National Highways Planning Response (NHPR 24-02)

Council's Reference: AL/11/24/OUT

Location: Land East of Westergate, Westergate

National Highways Ref: NH/24/05130

Figure 1: Typical Traffic Conditions – AM Peak Hour

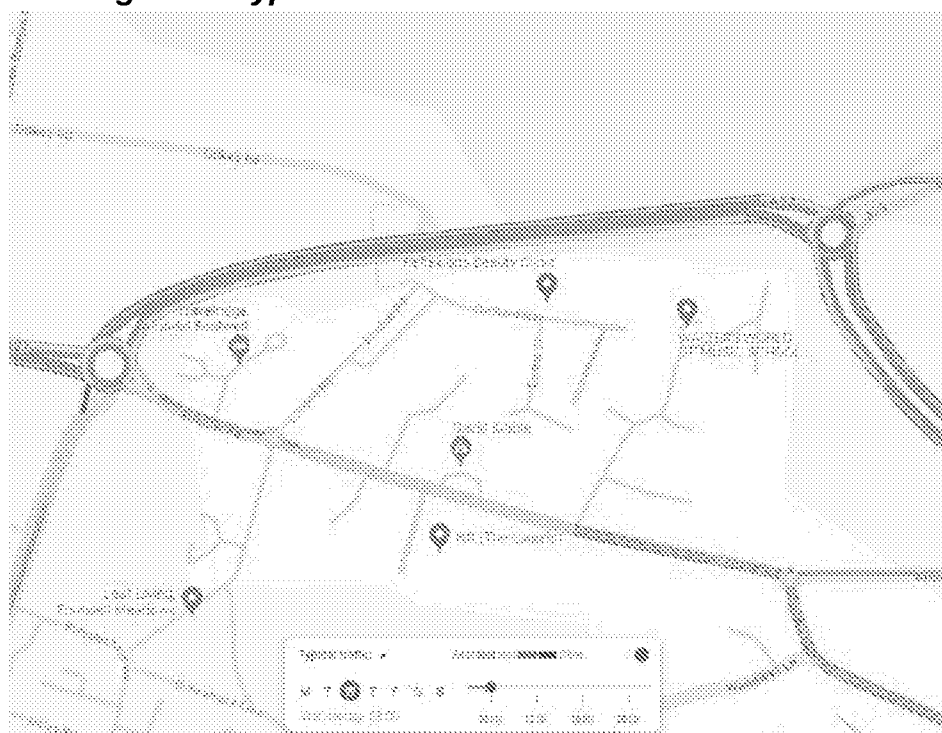
The typical traffic conditions from Google Maps shown in Figures 1 and 2 overleaf highlight that Fontwell West Roundabout and, to a lesser extent, the A27/ A29 junction (Fontwell East Roundabout) each experience delay during the AM and PM peak hours.
